Access Compliance Report

Public Rights-of-Way

Intersection ID: 18958	Main Street: GROVER_RD	Cross Street: OLD_PINEVILLE_RD	Location: SW
ADA ID: 4162C5473EE0	Ramp Type: Para	Initial Pass/Fail: Pass	Overall Compliance: No
		Severity Score: 0

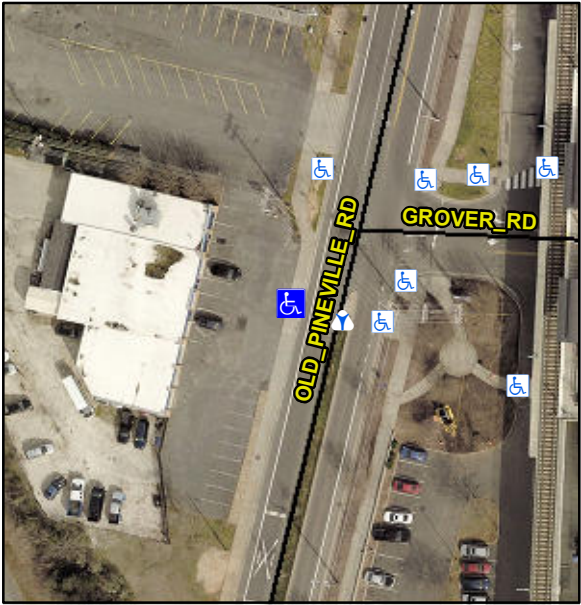
Codes/Mitigation Info/Possible Solution		Field Measurements/Component Compliance			
	Possible Solutions:				
	Remove & Replace Entire Ramp.				
	Surveyor Notes:				
	N/A				
	PROW/ADA:				
	Not Found, R304.2.2-Perp, R304.3.2-Para, R305.2				
Street 1 Name	OLD PINEVILLE RD				
Stop Condition-Street 1	None				
Street 2 Name	N/A				
Stop Condition-Street 2	N/A				
Total Cost:		\$	1600.00

Road Slope (%)	N/A	N/A	Clear Space?	Yes
	Road X Slope (%)	N/A	N/A	Clear Space to XWalk (in)	N/A
Yes	Any Obstructions?	No	Yes	Storm Grate/Utility Hazard?	No
	Obstruction Type			Storm Grate/Utility Type	
		N/A			N/A
			Yes	Surface Condition? (G/P)	Good
			Replace	Curb Slope (%)	17.4
